Consultation Response from: KC Environmental Health (Pollution & Noise Control)
2025/92743 - adj, 17, Hillhouse Lane, Fartown, Huddersfield, HD1 6EF
Variation of condition 13 (hours of operation) on previous permission 2019/93483 for erection of 4 A1/A3 ground floor units, 3 B1 offices and ancillary space, a free standing ATM and car park to vary the hours of use for units 1 and 2.
Date Responded:
Monday, 27 April 2026
Responding Officer:
HK
Responding Ref:
WK/202608934

(Picture 1)

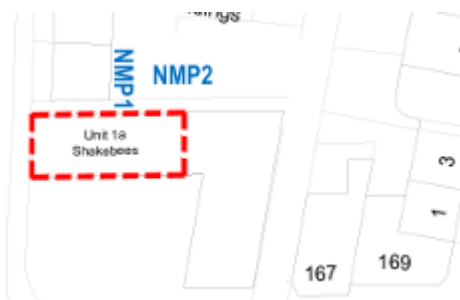
The applicant has submitted a Noise Impact Assessment, Ref: NIA/1517/26/617/v1.0, dated 13th March 2026, prepared by RP Acoustics Limited. The submitted noise impact assessment has undertaken baseline noise monitoring to determine the late-night noise climate at the nearest noise sensitive receptor and measured noise levels from the “*Unsilenced air intake fan continuous, broadband character*”. A photograph of the air intake was provided within the assessment (Picture 1 below):

The measured noise level of the “*Unsilenced Air Intake*” was identified as 56dB L_{Aeq}. However, as can be seen in the above ventilation extraction system (Picture 2), the air intake and the ventilation extraction system are not the same equipment. It is not clear where the “*Unsilenced Air Intake*” is positioned in relation to the noise monitoring positions or the nearest residential receptor. However, as can be seen in picture 2 (above), it is the ventilation extraction system that is within close proximity to the noise sensitive receptor that poses a potential noise impact.
